Service Bulletin #108

Subject: Wearing of recoil starter rope on Air Duct - Blower Housing (37947)

Models: #55091, 35210A, 55098 and GIS 7510A87 Compact Snowthrowers

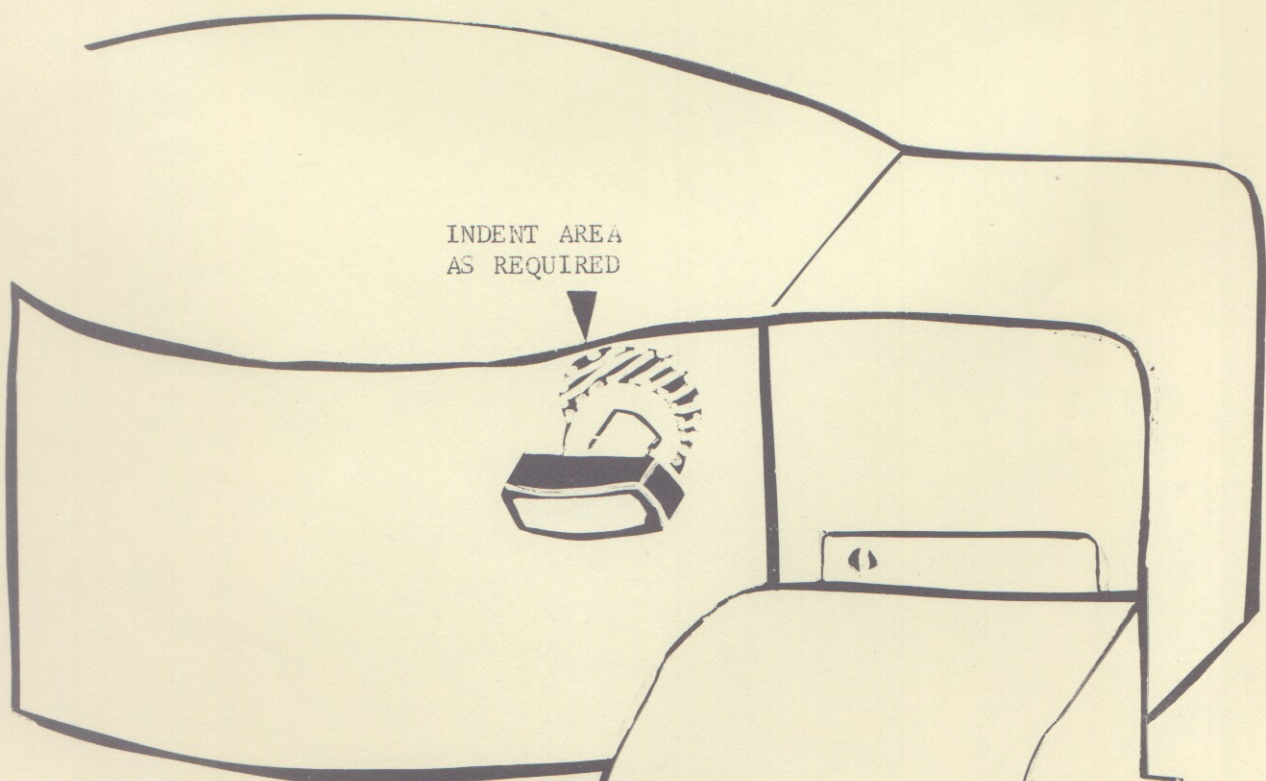
It has been brought to our attention that chaffing and failure of the recoil rope has been experienced on some of the above models. This is caused, by the recoil rope rubbing the edge of the cut out in the #37947 Air Duct when pulling the rope vertically.

Correction of this condition is achieved, by merely indenting the area above the recoil outlet slightly with a ball-peen hammer, so the rope will clear. Fig. 1 illustrates the area which should be indented for clearance.
